**GOULBURN RIVER SOLAR FARM**

Amendment Report

December 2023

Prepared by  
Umwelt (Australia) Pty Limited  
on behalf of  
Lightsource bp

**FIGURE 1.3**  
Design Refinements

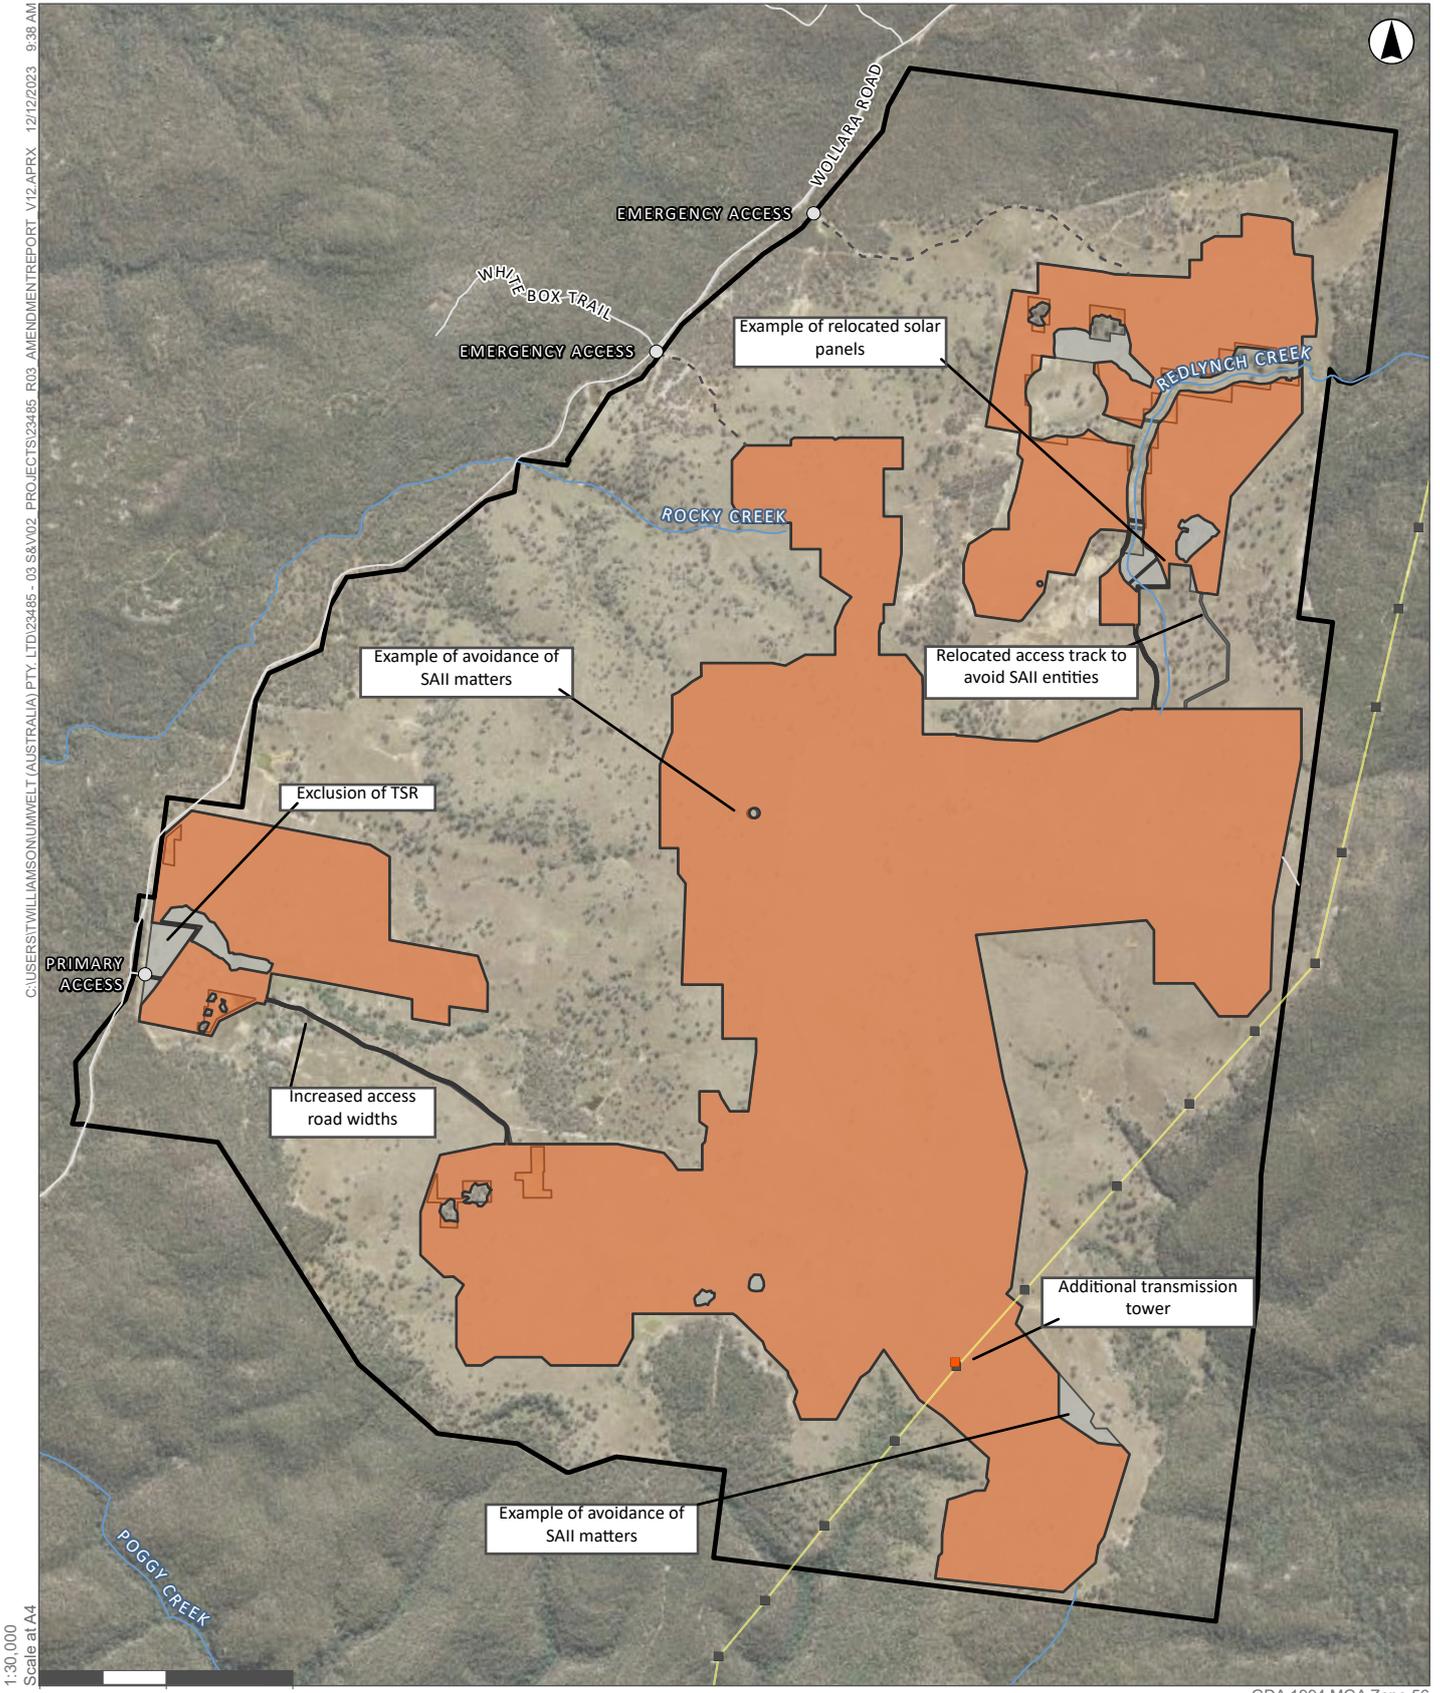
This Amendment Report presents Design Revision D, the Amended Project, which has been prepared following exhibition of the EIS and receipt of submissions. The Development Footprint revisions can be seen in **Figure 1.3**. A summary of the changes made to further avoid impacts between Design Revision C (the EIS Project) and D include:

**Proposed Section of Road Sealing along Wollara Road**

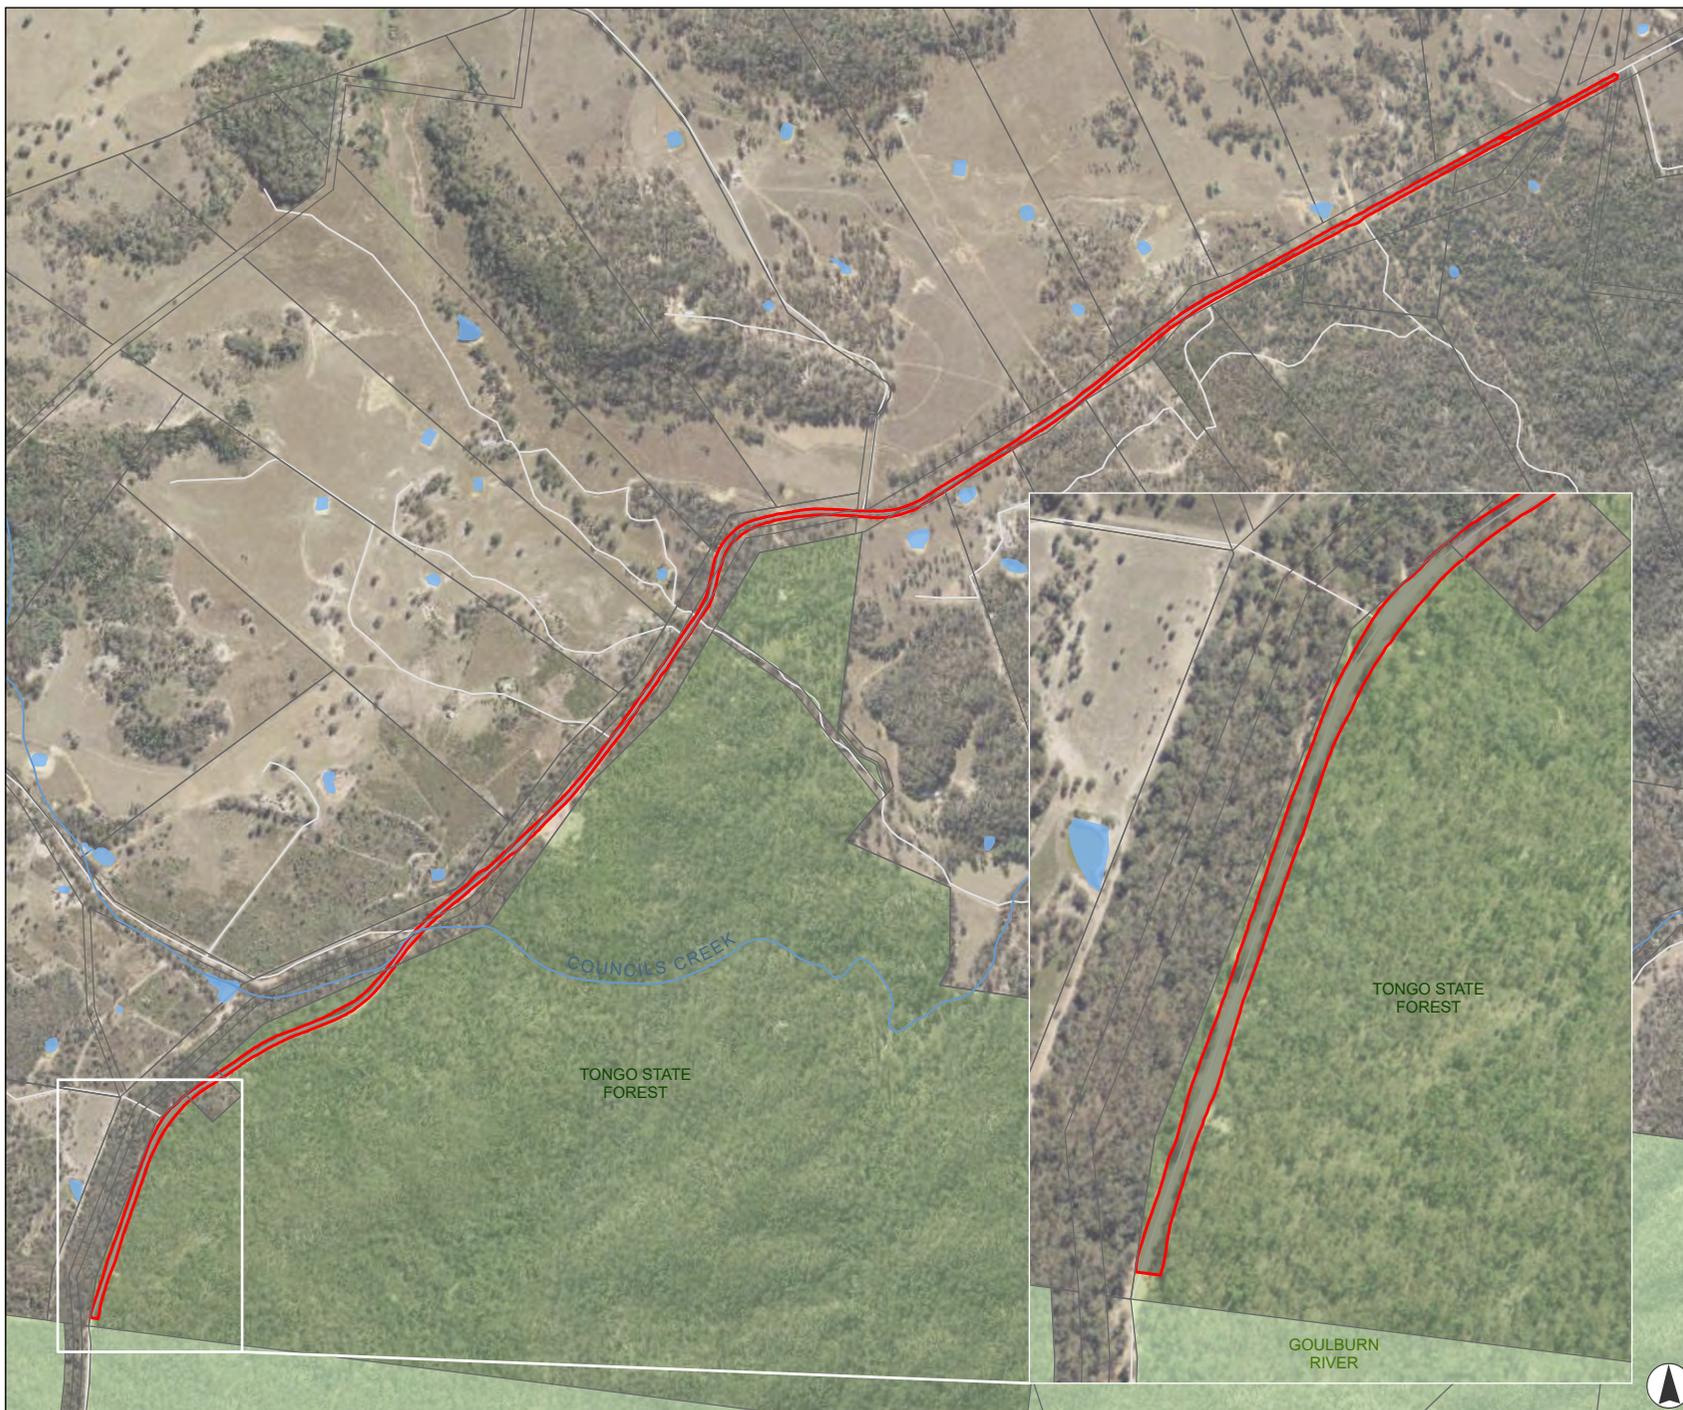
LSbp are now proposing additional road upgrades as community benefits under the Voluntary Planning Agreement (VPA) with the UHSC. These works would also facilitate further improvements to enable the safe movement of heavy vehicles. The proposed road upgrades include:

Landowners consent for the proposed works is provided in **Appendix B**. The proposed Wollara Road and Ringwood Road upgrades are illustrated on **Figure 3.3** below.

**FIGURE 3.5**  
Proposed Centralised BESS  
Layout

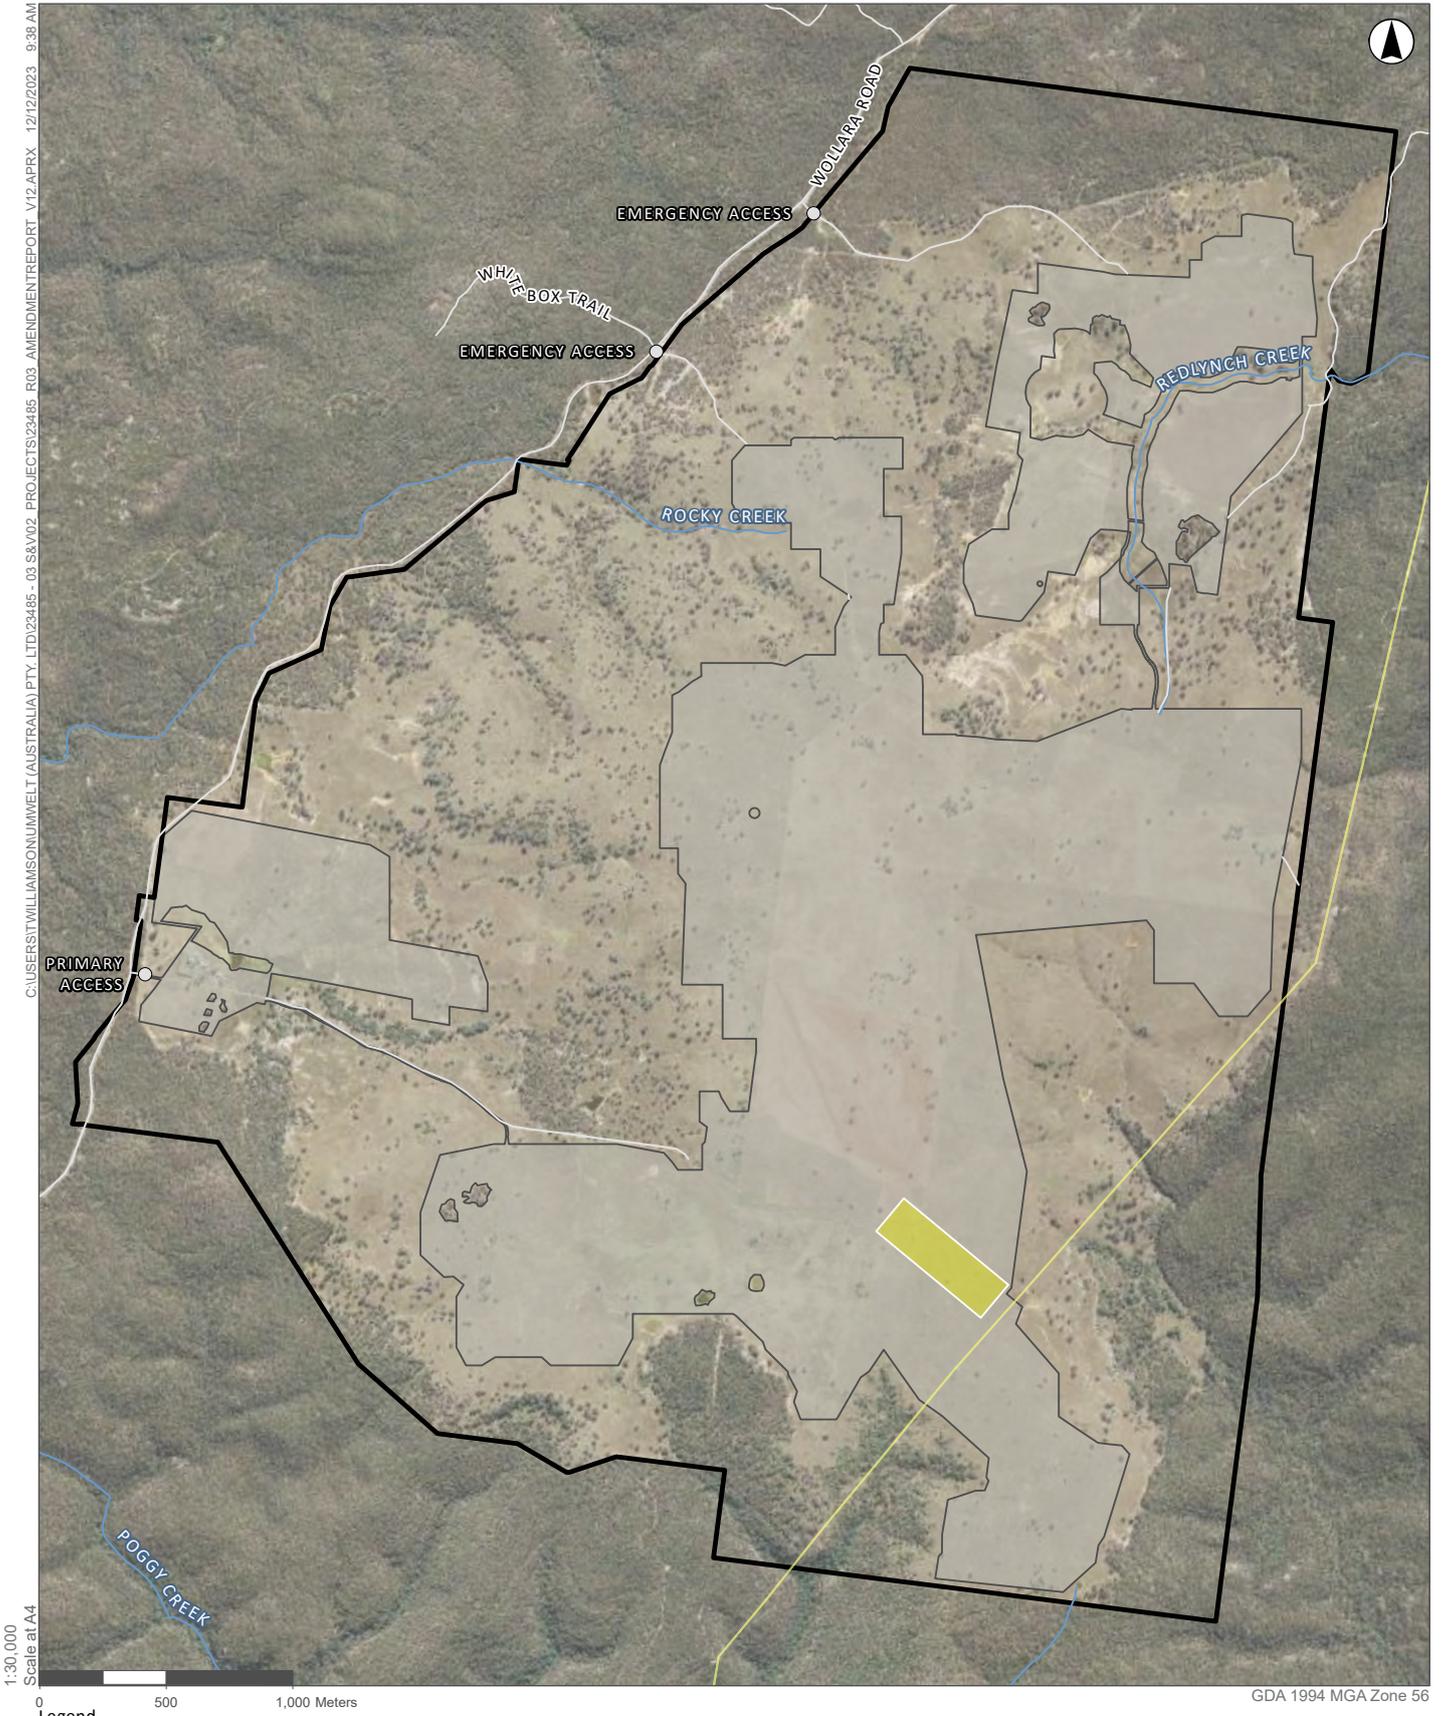
LSbp is also seeking to amend the Project EIS to include the option of a decentralised BESS, to allow for greater flexibility in the design of the final BESS facility. The decentralised BESS option involves 560 individual 6.1 m (i.e., 20 foot) battery containers and DC-DC converters, and associated infrastructure being situated next to the PV inverter stations located throughout the solar arrays, rather than in a centralised location as proposed in the EIS. The layout of the centralised and decentralised options is shown in **Figure 3.4** and **Figure 3.5**.

**FIGURE 3.7**  
Amended Project –  
Development Footprint &  
Internal Layout

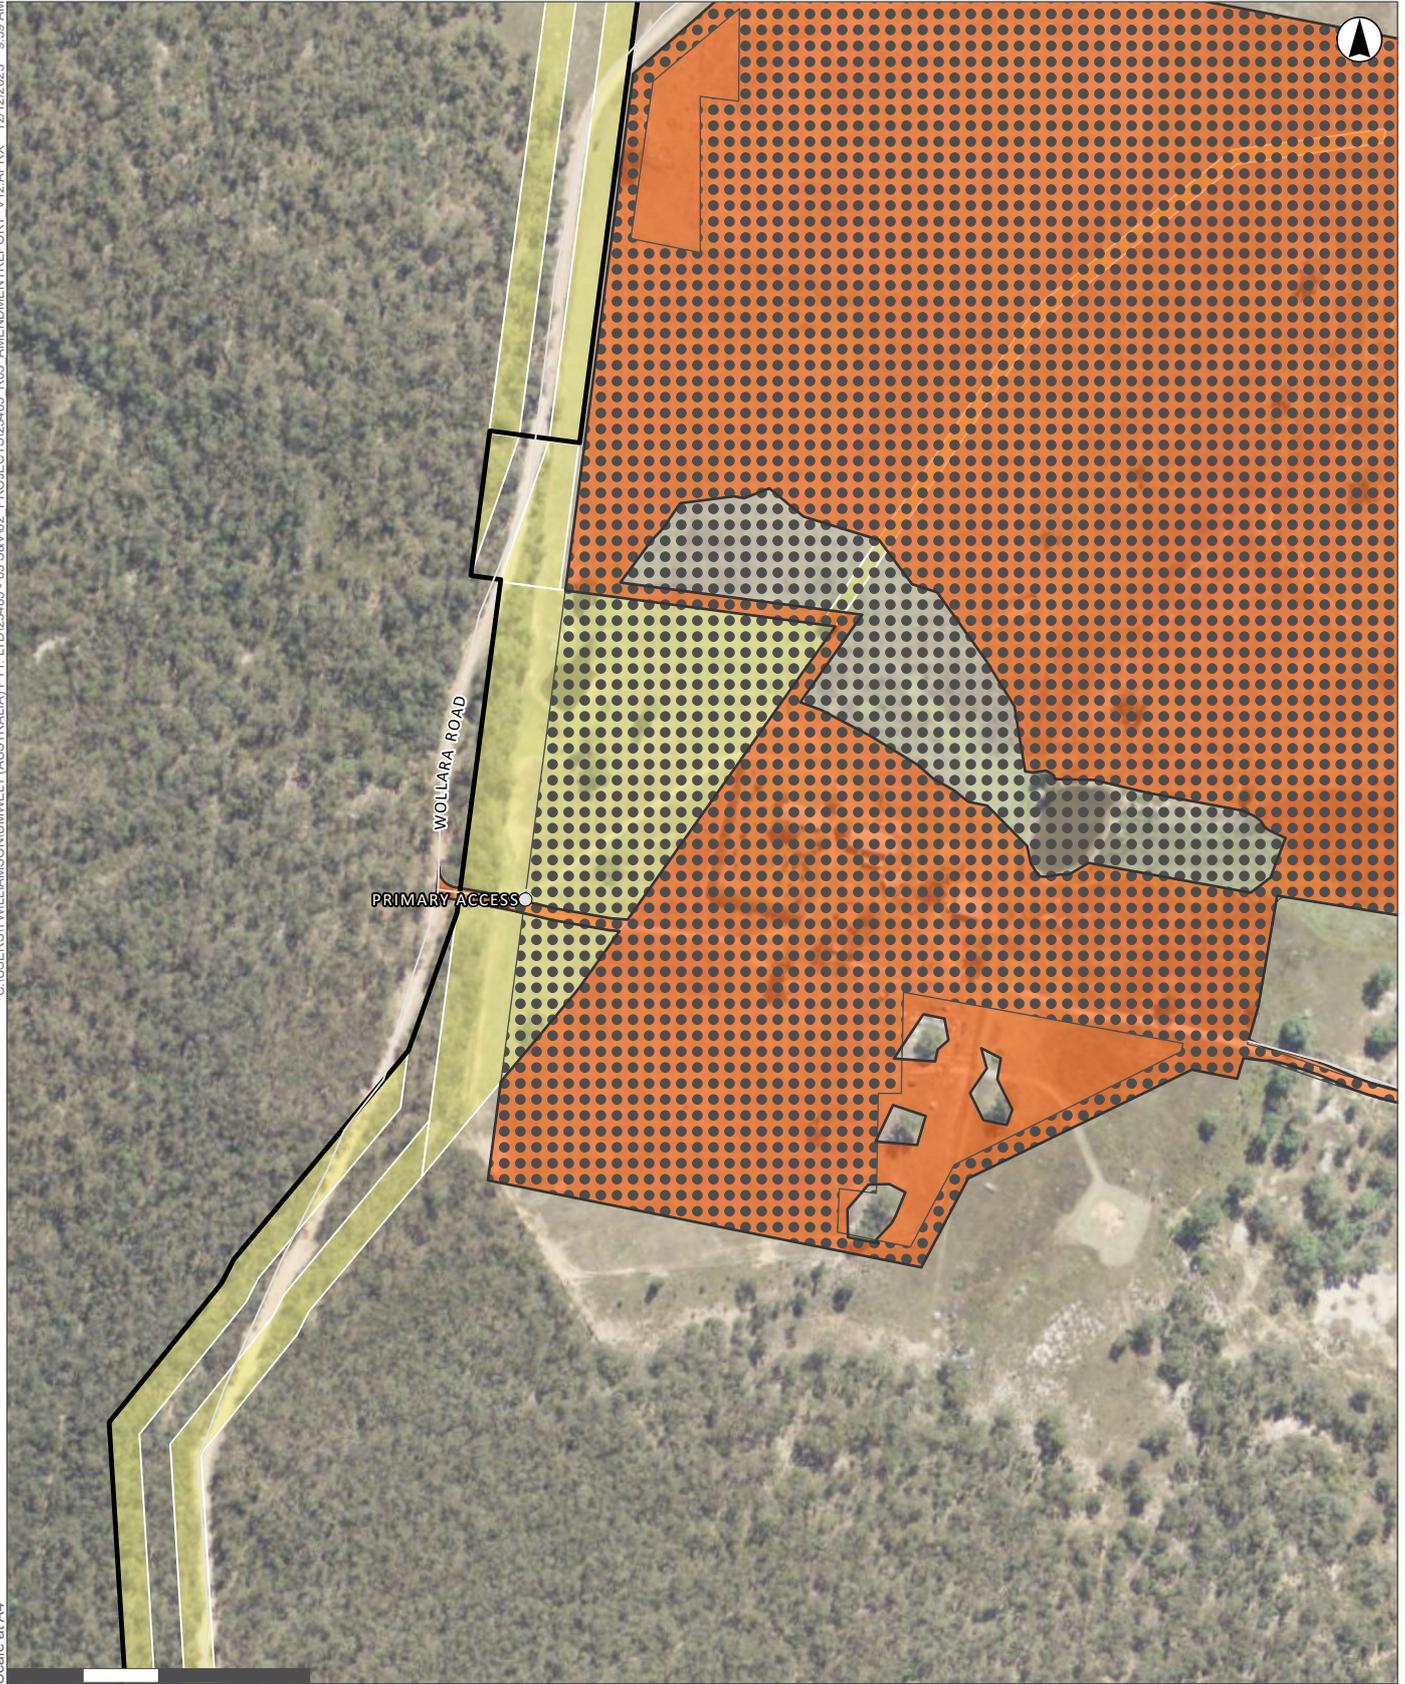
The positioning of solar panels and other Project infrastructure has been amended in response to comments received during the EIS exhibition stage and further consultation with NSW Biodiversity and Conservation Division (BCD) during the RtS phase.

Solar panels within the EIS Project Development Footprint have been relocated to previously unused areas within the Project Area to increase avoidance of PCTs and threatened species habitat, with a focus on reducing impacts to SAI entities. The access track between the central and north eastern areas of solar panel arrays has also been realigned, to minimise clearing within mapped important habitat for Regent Honeyeater and Box Gum Woodland.
